APPELLANT INFORMATION

Project Name:	The White Building Renovation		
Applicant or Owner Name:	Bradyn Furry		
Location of Subject Site:	206 McKenzie St.		
Case Number:	2025-010494-HDRB	Permit Number (if applicable):	
Final Action Appealed:	<input type="checkbox"/> Issuance of Building Permit	<input checked="" type="checkbox"/> Other Final Determination of LUD Director	
Final Action of Board or Commission:	<input type="checkbox"/> Planning Commission	<input type="checkbox"/> BCD-DRC	
	<input type="checkbox"/> Board of Adjustment	<input checked="" type="checkbox"/> Historic District Review Board

Description of the final action appealed from, and date on which final action was taken: July 22, 2025: Motion 4A, 4B, 4C, 4D: A list of windows and doors approved for replacement and those denied replacement.

2025-010494-HDRB, 206 McKenzie St., Downtown and Eastside Historic District, Contributing, Bradyn Furry, agent for Mindy Hale and FC3 Ltd. Co., owner, requests approval to replace all the doors and windows which requires an exception to 14-5.2(D)(1)(a) for the removal of historic material; construct a new detached steel carport to a height of 8'-8" with roof-mounted solar units within

1 NORTH - EXISTING
3/16" = 1'-0"

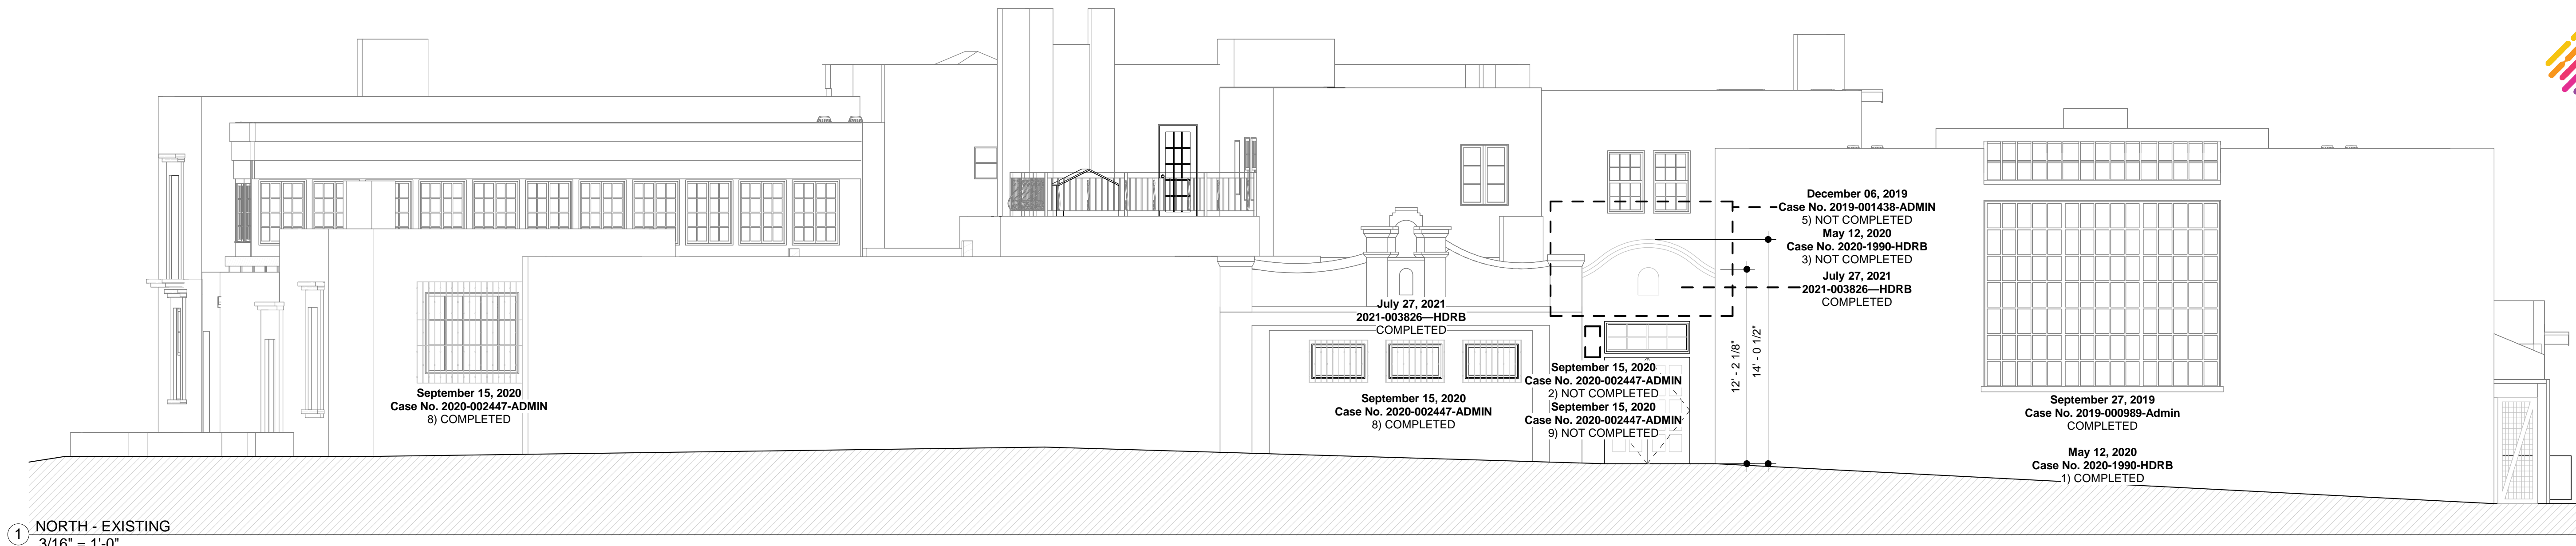
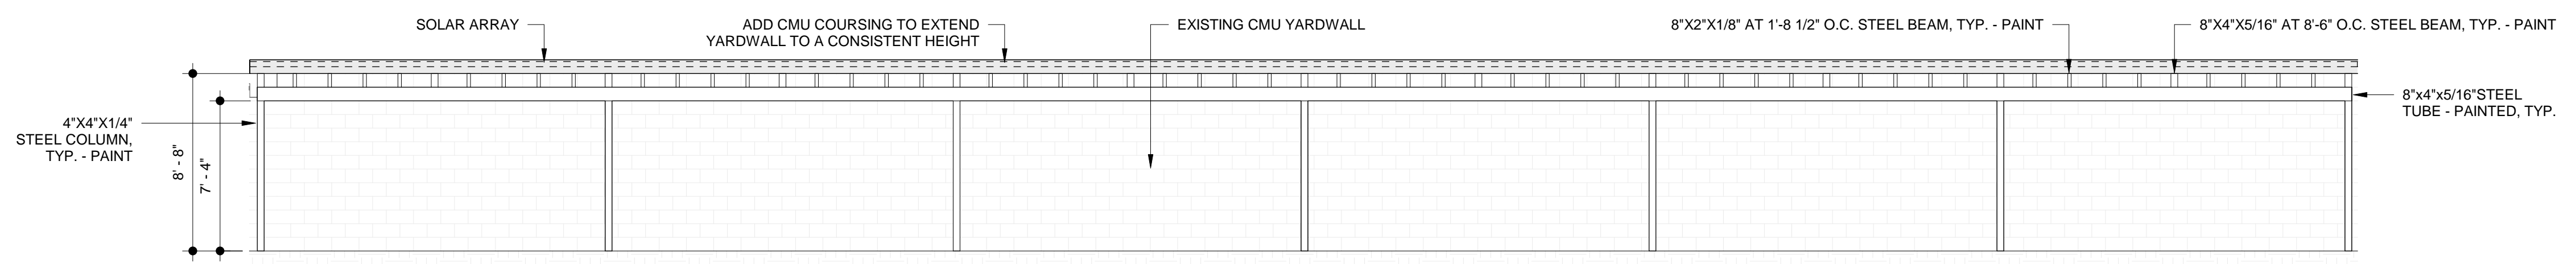
- 3) Change the overall height by 3'-3" from 14'-0 1/2" to 17'-3" high from a previously approved parapet on the McKenzie St for which an exception is requested to 14-5.2(D)(2)(c) addition to a primary façade.

Acting Chair Bienvenu shared that the next item for discussion was item three, which requires an exception, and staff does not recommend approval. He explained that this item is for changing the overall design and height from the existing height of 14 feet 1/2 inches to 17 feet 3 inches in height, and that the 14 feet 1/2 inches was a previous board-approved modification, and asked if staff would clarify the reasoning for the recommendation of denial.

Mr. Duran confirmed the board did approve the previous modification to the height. Mr. Duran shared the image of the previous approval for the north façade. He stated that there were no issues with the design when it was previously approved. However, now the as-built design before the board for approval is the revised pre-board approval construction to complete the façade. The current infrastructure needs the extra 3 feet 3 inches to provide screening for rooftop appurtenances. Staff had concerns with the architectural design, raising what was approved because it changed the character of that northern façade; therefore, staff are not recommending approval. However, there is the fact that the applicant needed this to provide the necessary screening for their rooftop skylights and other appurtenances, and it is as built.

Acting Chair Bienvenu questioned why the parapet was not previously addressed for additional height. If it was necessary to raise the parapets to be higher to screen rooftop appurtenances why was the issue not discussed several years ago when the parapets were previously discussed.

Acting Chair Bienvenu asked why that wall couldn't have just been rebuilt exactly the way it was approved by the board the last time, or couldn't be rebuilt exactly the way it was approved, other than wanting to add the skylights.

Mr. Duran showed the façade before the construction. He stated that staff evaluated the applicant's response and the previously approved design in 2021. The previous approval had a lower parapet, and that lower parapet allowed the fenestrations from the designs on that northern facade to complement what is currently there. The new design takes over that primary façade, and that conflicts with what historic preservation is trying to do. It should be aesthetically pleasing, but it needs to retain the integrity of that north primary façade. To create a new facade while trying to replicate, but which overwhelms the northern façade, is not consistent with what the board previously approved. The decorative feature on the parapet is not sufficiently distinguished from the historic feature on the adjacent parapet; that was the concern from staff that it detracts from the primary facade and what is currently established.

a structural compromise of a wall doesn't mean that you need to add three and a half feet to a parapet or to a facade and the idea that you would even suggest allowing steel to be exposed on a primary facade is outrageous and not in keeping with the requirements of the of the district.

6 NEW CARPORT FRONT ELEVATION
3/16" = 1'-0"

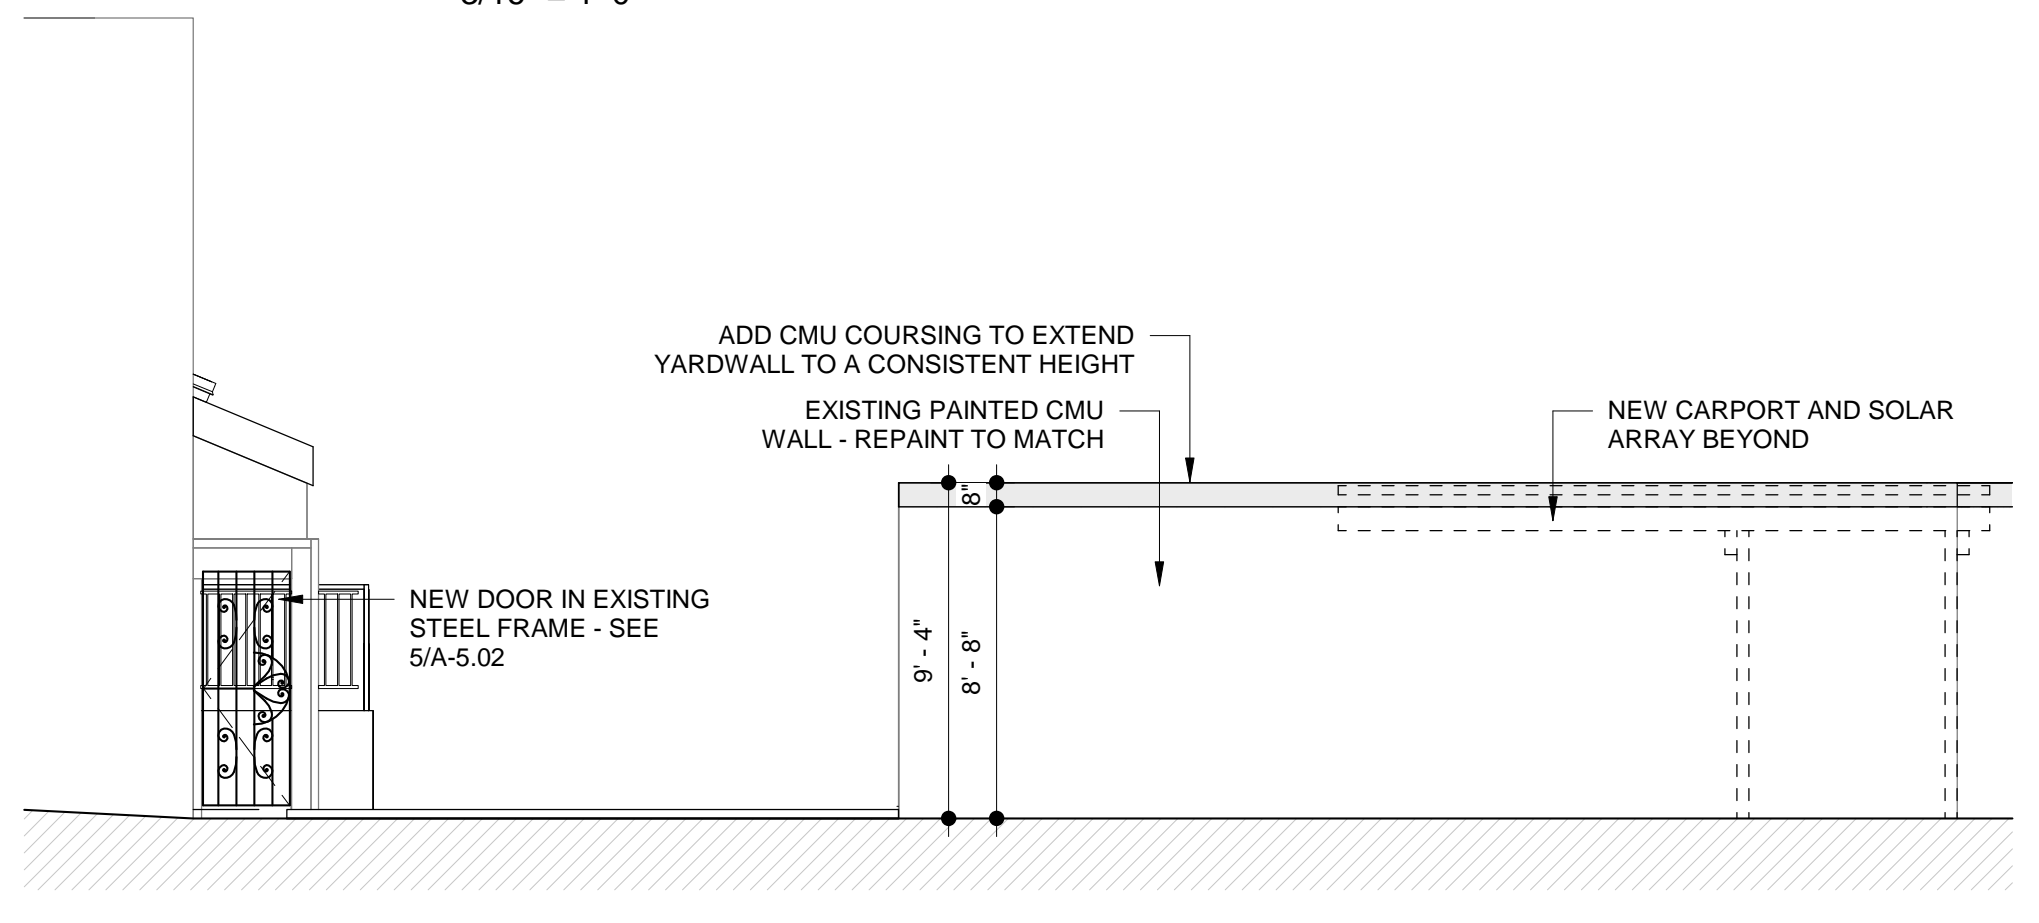
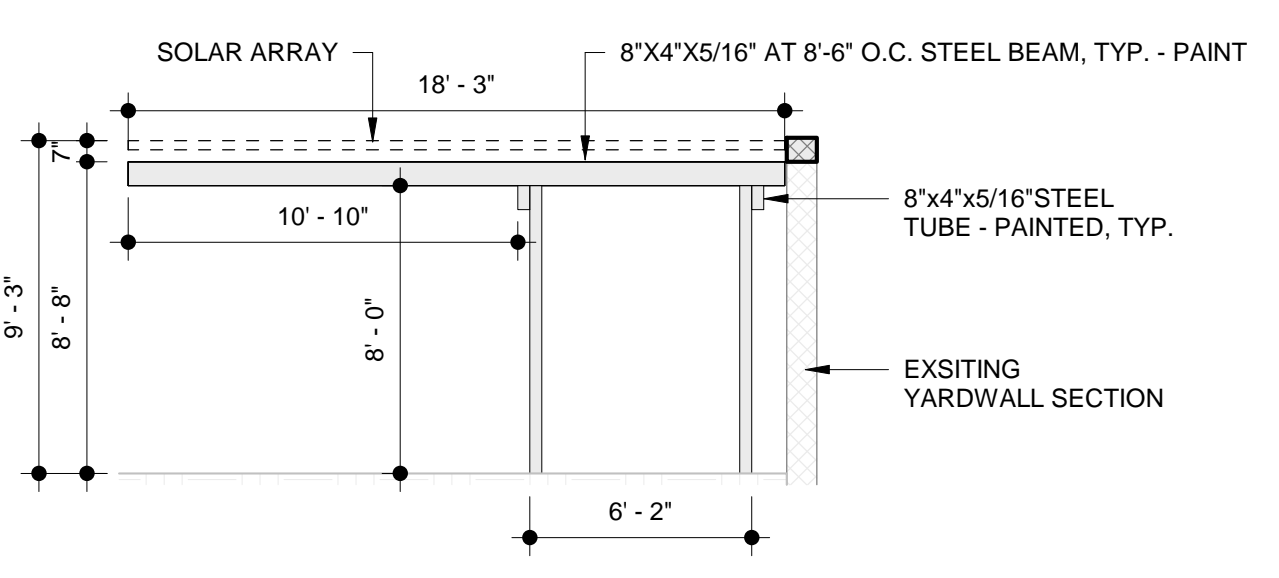
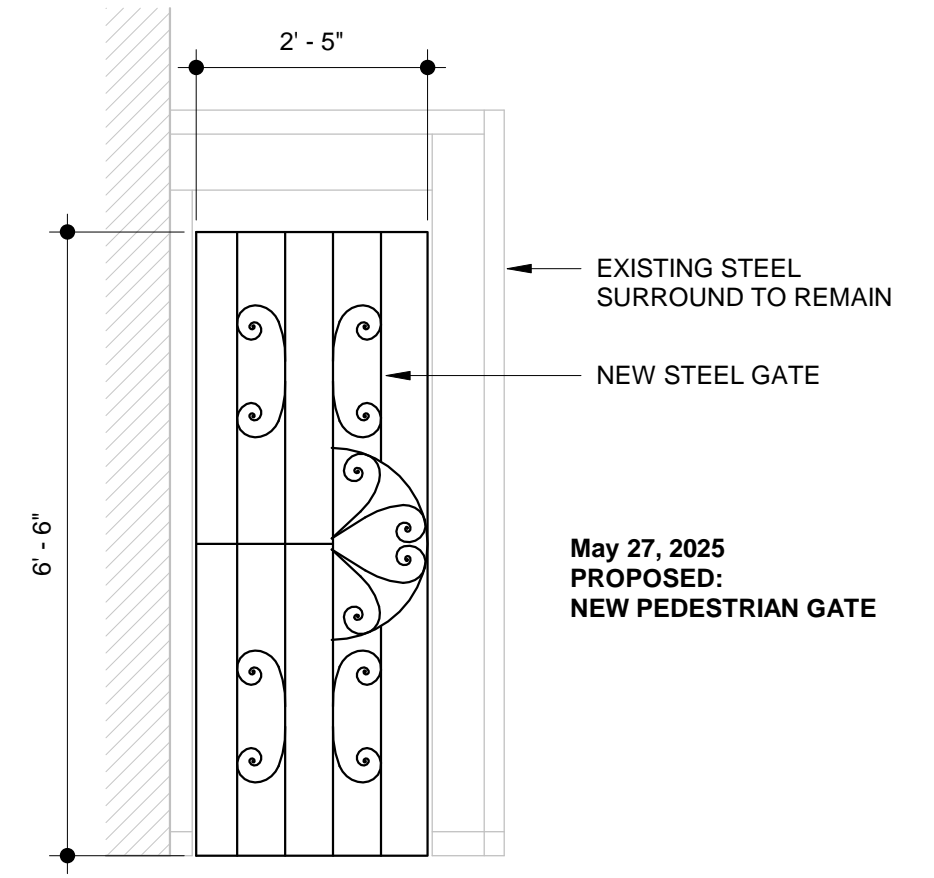
Applicant Response: The proposed carport will be hidden from view within the existing perimeter yard walls which will be raised in places which have an inconsistent height. The overall height of the yard wall will be adjusted to fully screen the carport from public view. The building is in the Business Capital District – McKenzie Street subdistrict which does not have a restriction on the height of walls and fences, so yard wall heights can be easily adjusted for full screening from the public.

Staff Response: Staff has evaluated the applicant’s response and finds that this exception criterion has been met. Generally, metal gates and other metal structural elements need Board approval with an exception that will be publicly visible. The applicant proposes the metal carport will not be publicly visible from Griffin Street, Grant Avenue, or McKenzie Street, which is acceptable.

Applicant Response: Because the auto-court within the perimeter yard-walls is tight and maneuvering within is limited, a cantilevered carport is proposed. A cantilevered structure provides the necessary framework for solar panels while keeping the largest possible, open maneuverable space for cars to access underneath. A wood structure, which would typically be proposed for this area, with columns at the corners and at the extents of the structure, would limit the maneuverability of the cars accessing the parking spaces below, making it almost impossible to use. A cantilevered structure of the size required requires a steel structure to achieve the necessary clear space for maneuverability.

Staff Response: Staff has evaluated the applicant’s response and finds that this exception criterion has been met. The auto-court area is limited in space and maneuverability and to provide parking for those who live and work at 206 McKenzie Street, the metal carport will provide the structural infrastructure needed to maximize the parking availability.

① SOUTH - EXISTING
3/16" = 1'-0"

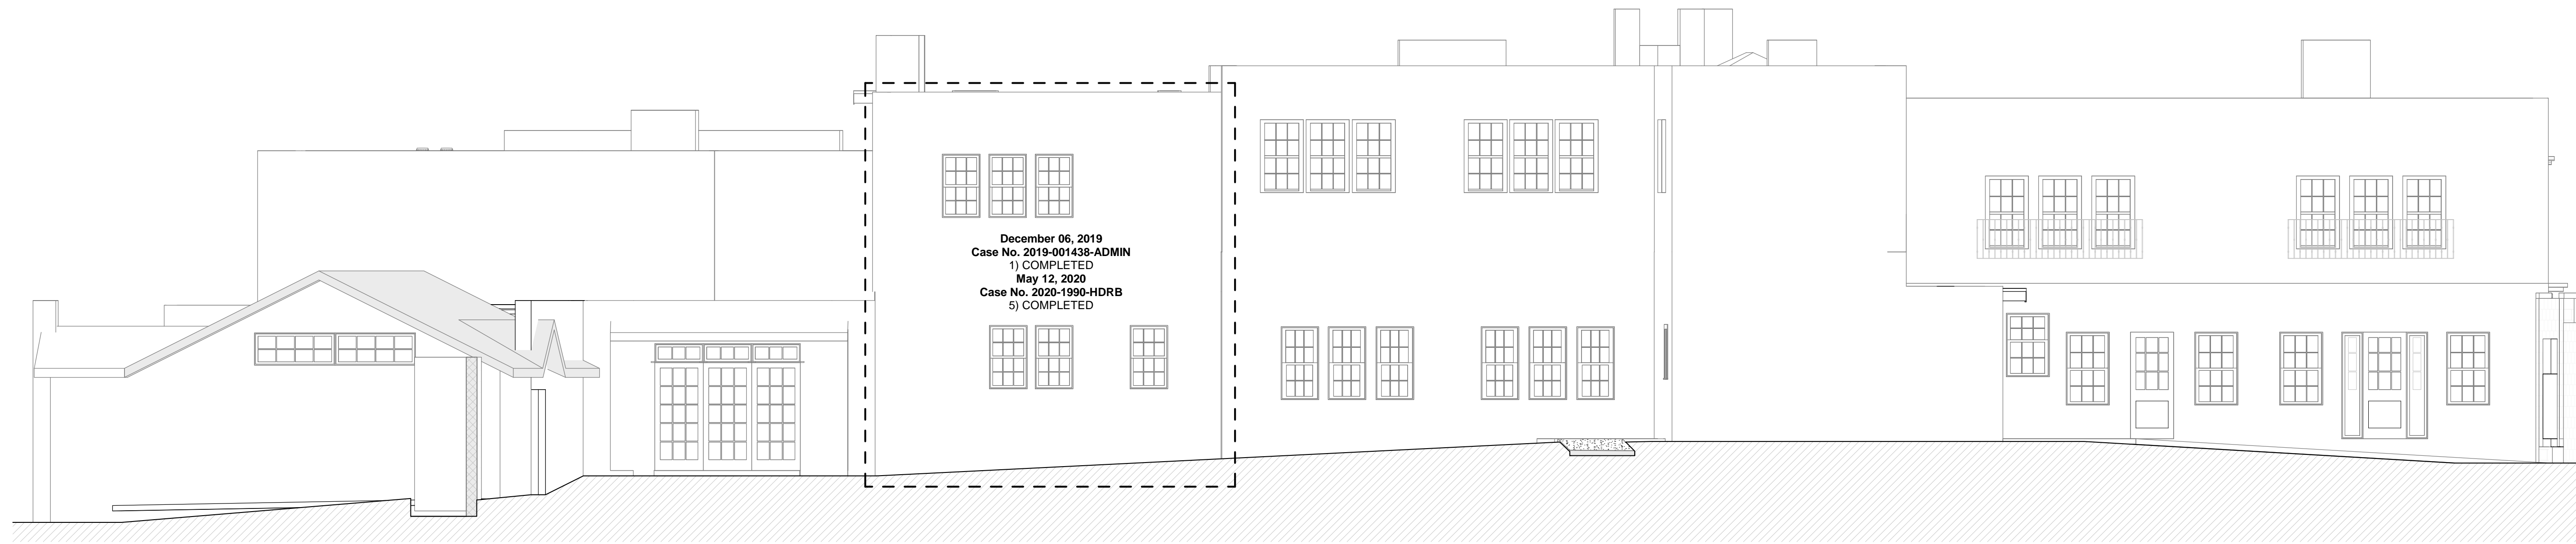
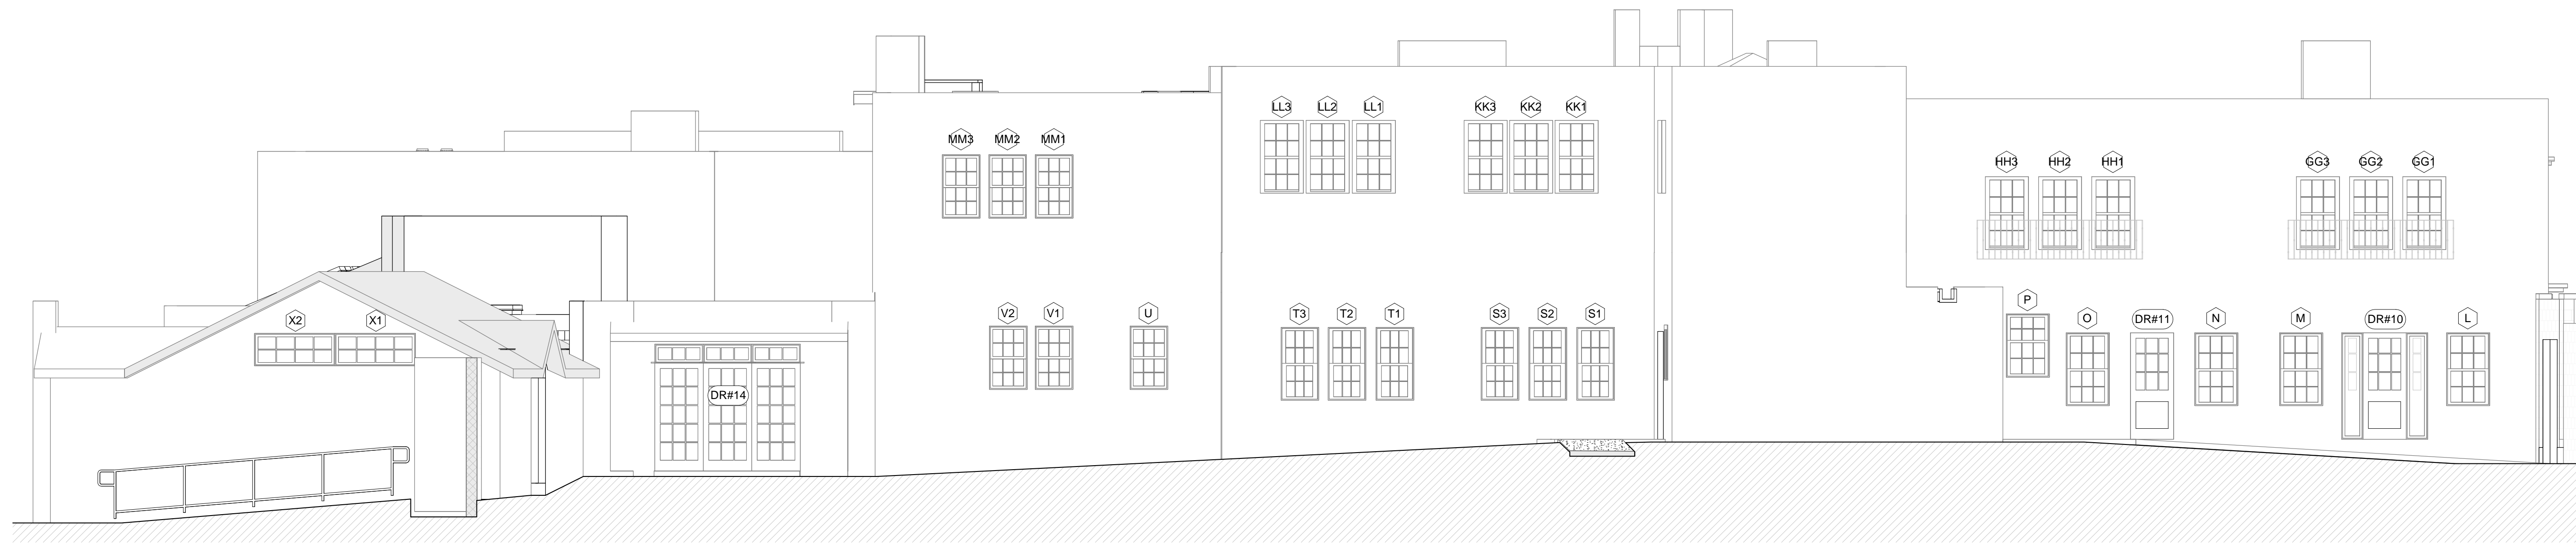
Member Cherry moved in case 2025-0104954-HDRB at 206 Mackenzie Street in respect to window replacement on the south elevation approve replacement of X1 and X2, replacement of Door 14, and windows V, U, T, S, O, N, M, L, replace D10, D11, and D12 and window Q on the first floor and restore MM, LL, KK, GG, HH, and II. Member Mather seconded the motion.
